RESPONSES TO BETA GROUP, INC. TRAFFIC IMPACT ANALYSIS PEER REVIEW COMMENTS
DATED JULY 16, 2021

RESPONSES TO BETA GROUP, INC. TRAFFIC IMPACT ANALYSIS PEER REVIEW COMMENTS
DATED AUGUST 30, 2021

RESPONSES TO BETA GROUP, INC. TRAFFIC IMPACT ANALYSIS PEER REVIEW – PARE’S
RESPONSE TO COMMENTS NO. 2 DATED NOVEMBER 2, 2021

DRAWING NO.:
C1.0
SHEET NO. OF

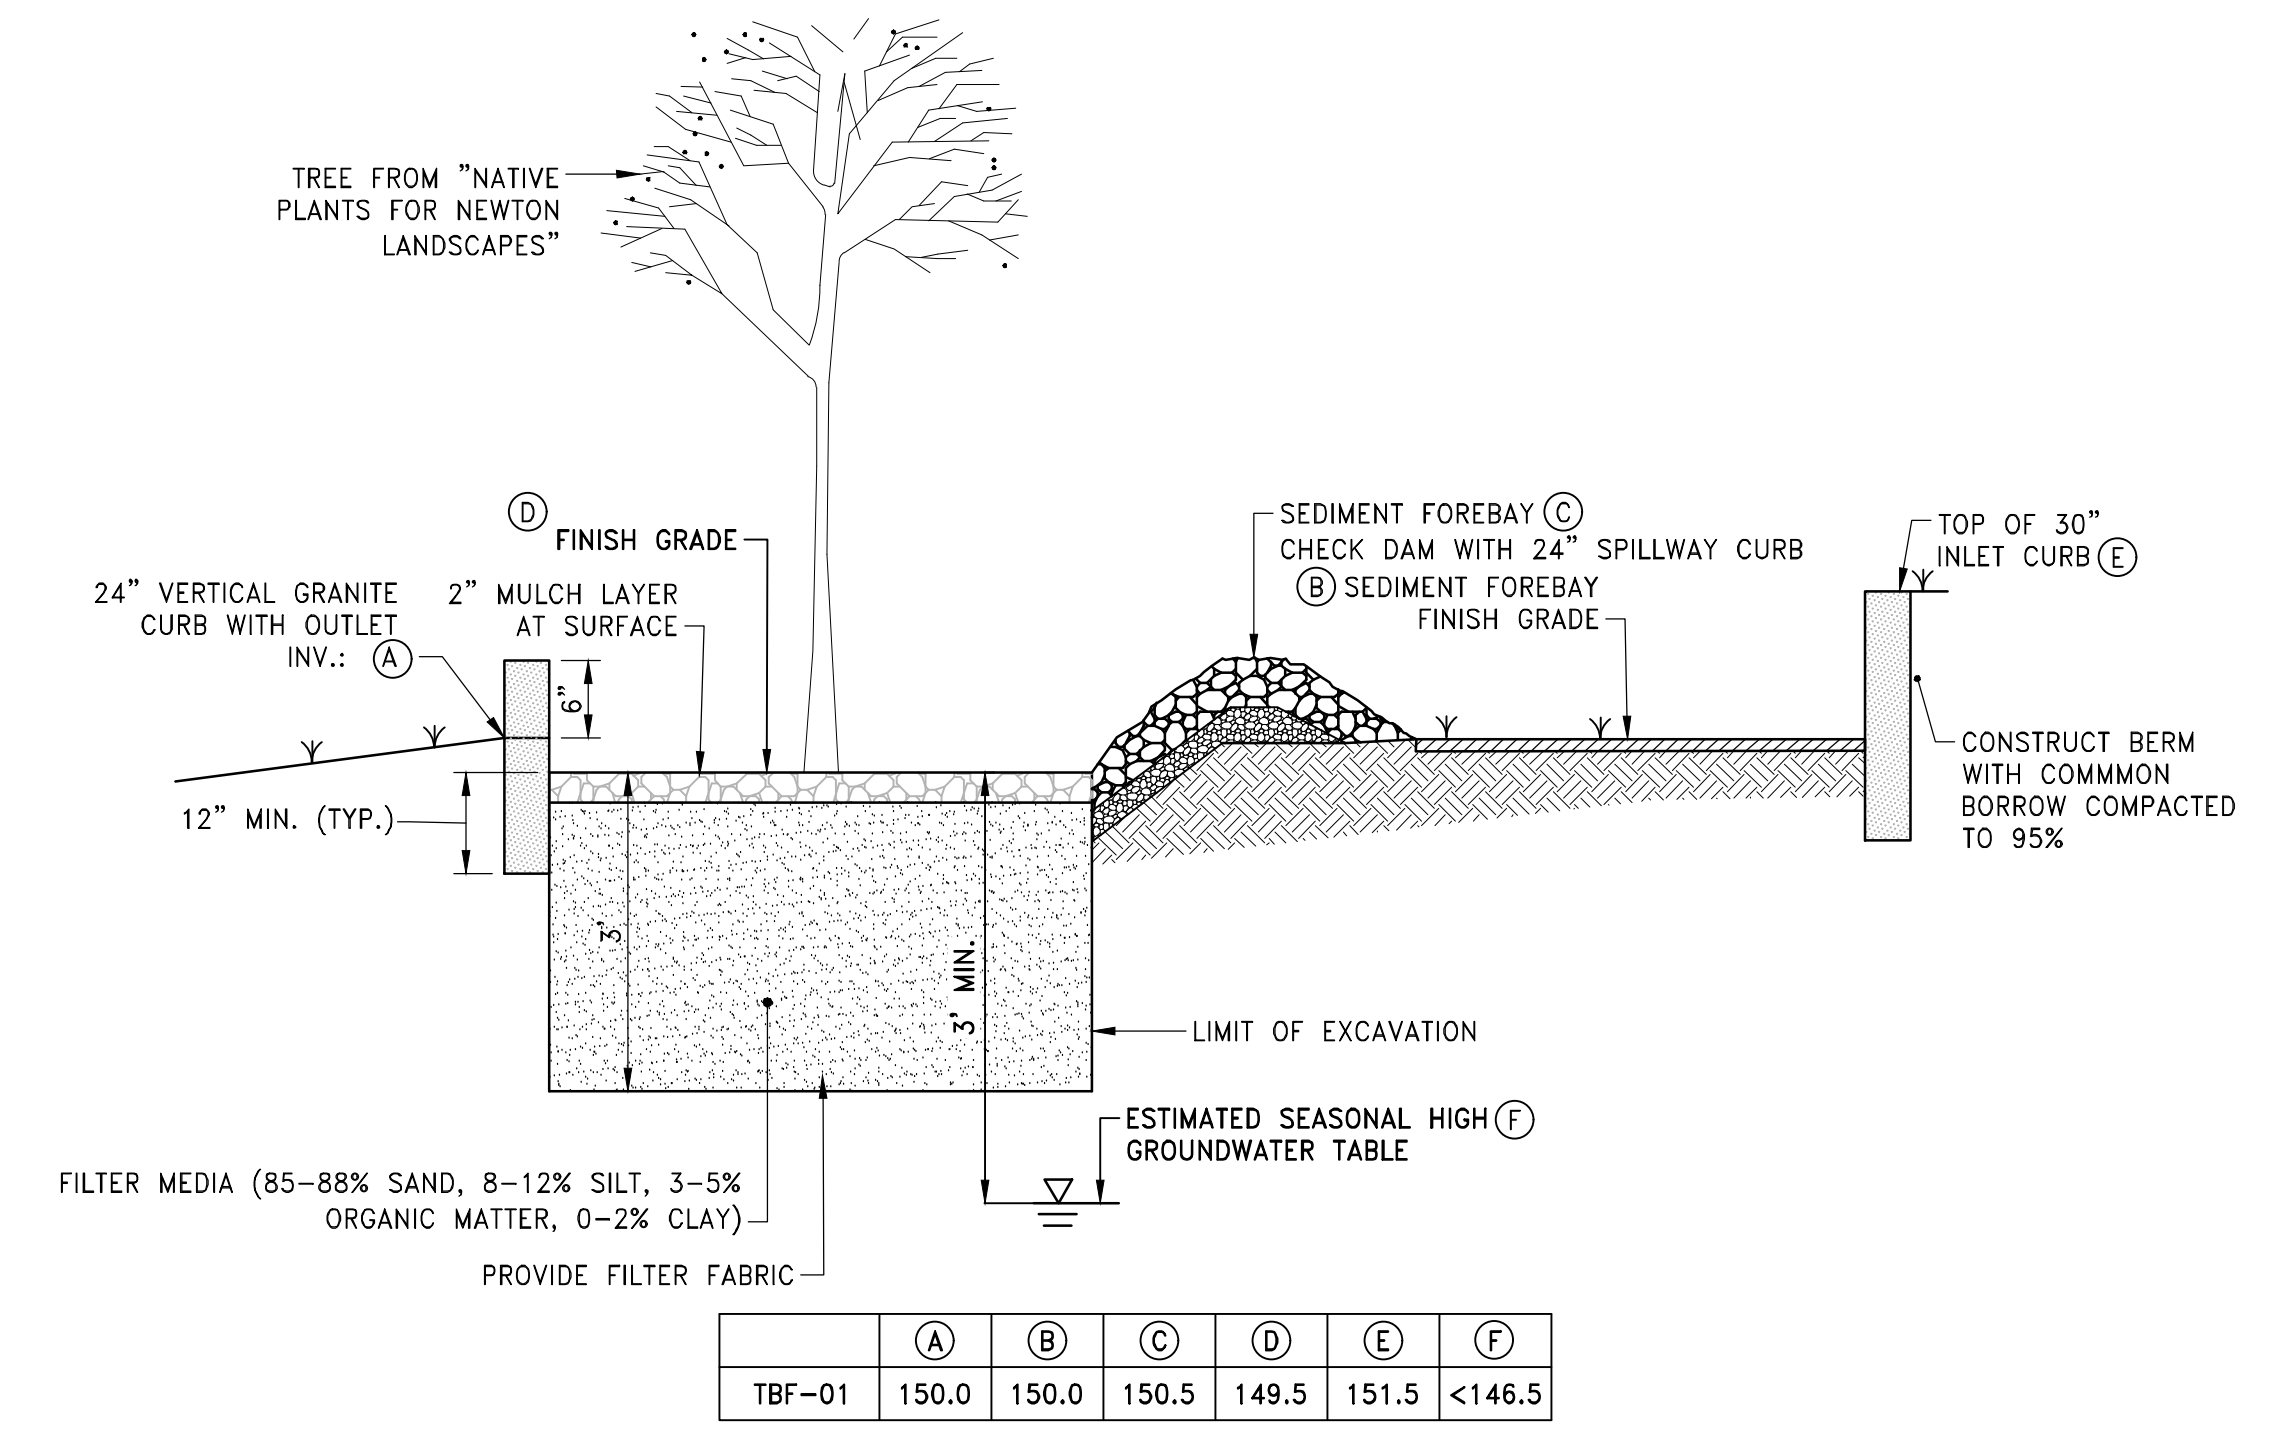
4. **COMMENT:** Please verify the location of the proposed drive-thru pickup window to show the accurate vehicle queue.

BETA2: Please provide the latest site plan.

Relating to the turning assessment completed, please define how the applicant will restrict vehicles larger than a passenger vehicle from the drive-thru lane. In addition, a light pole is shown in the site plan within the drive-thru lane that will further constrain vehicles. Is the proposed light pole

11. **COMMENT:** Please clarify why an 18-foot-deep stall is proposed rather than the minimum required of 19'.

BETA2: Please provide an updated site plan showing 19' long stalls.

4. **COMMENT:** Please verify the location of the proposed drive-thru pickup window to show the accurate vehicle queue.

BETA3: Please provide the latest site plan.

RESPONSE: The proposed pick-up window is located at the east side of the building as depicted on C1.0 and represents an accurate vehicle queue.

PARE2: Latest site plan is provided.

Signage and a revised light pole location has been incorporated on the plan. Maintenance of the light poles will have to be agreed upon between the Property Owner and Applicant.

RESPONSE: The existing site has 18-foot long parking stalls. The plan has been updated to reflect the City requirement of 19'.

PARE2: The latest site plan is provided.

RESPONSE: Latest site plan is provided, see attached.
